**Structure in ROW Request**  
**8+50 to 9+50 +/-**  
**West Chicago Street**  
**Aug. 4, 2006**

Village at Founders Park  
 Structure in ROW Request  
 8+50 to 9+50 +/-  
 West Chicago Street  
 Aug. 4, 2006

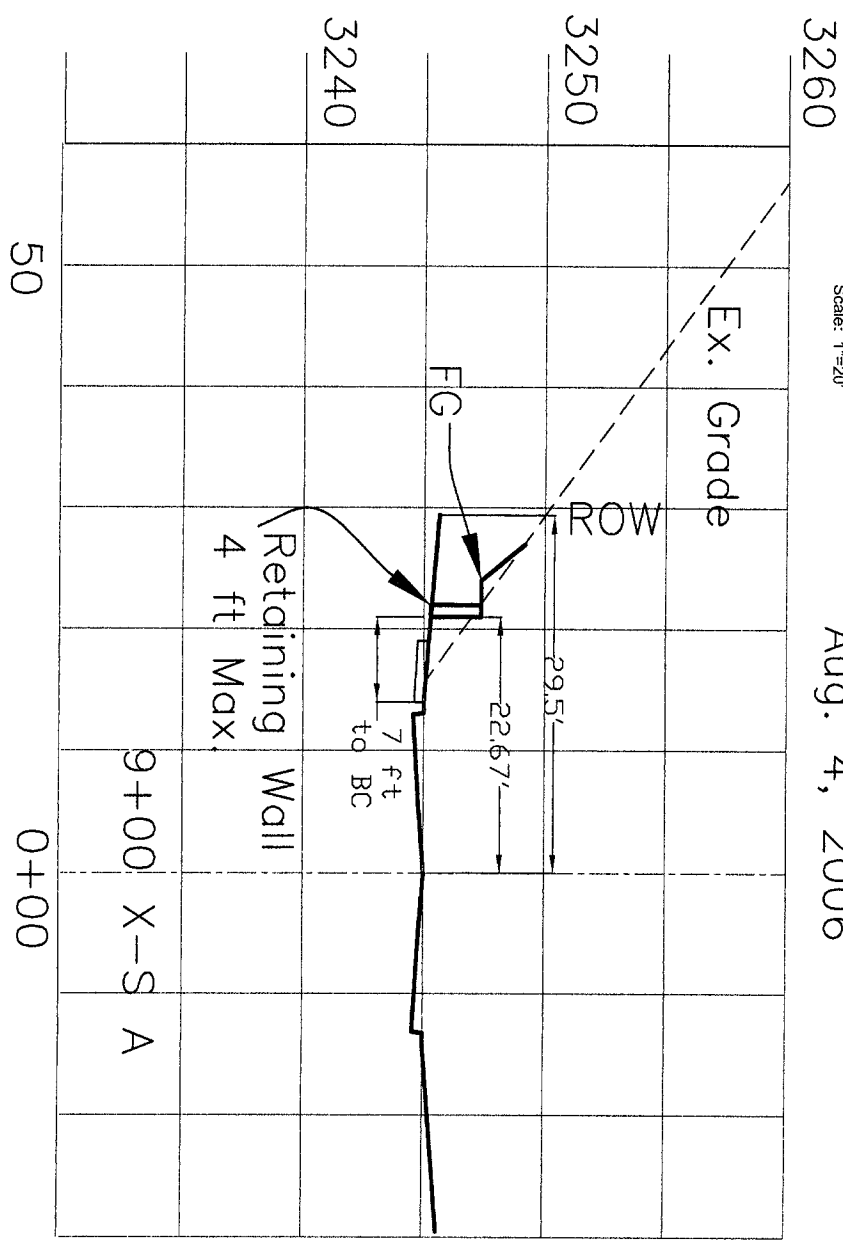
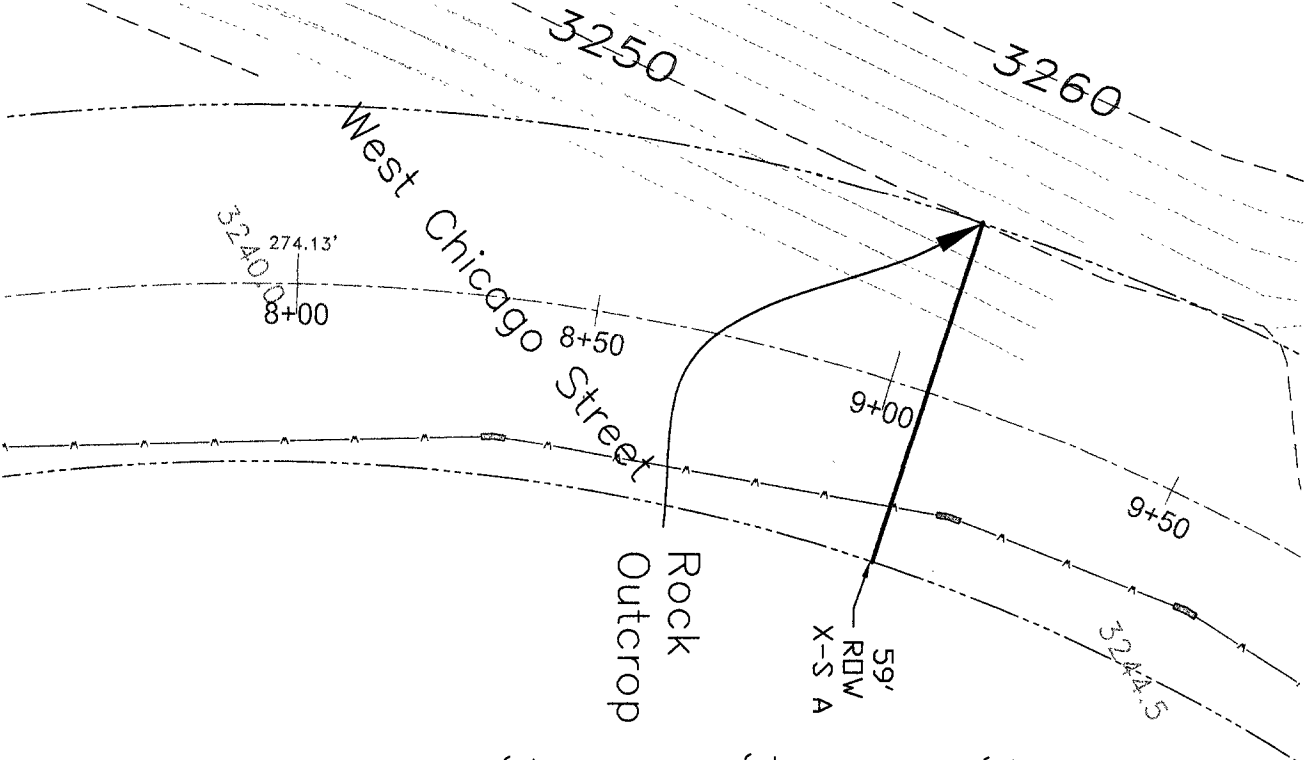
REVISION 7-28-06  
Sewer Main, Underdrain, Inlets  
REPLACE 10" PVC Water Main w/  
12" CL 150 PVC Water Main
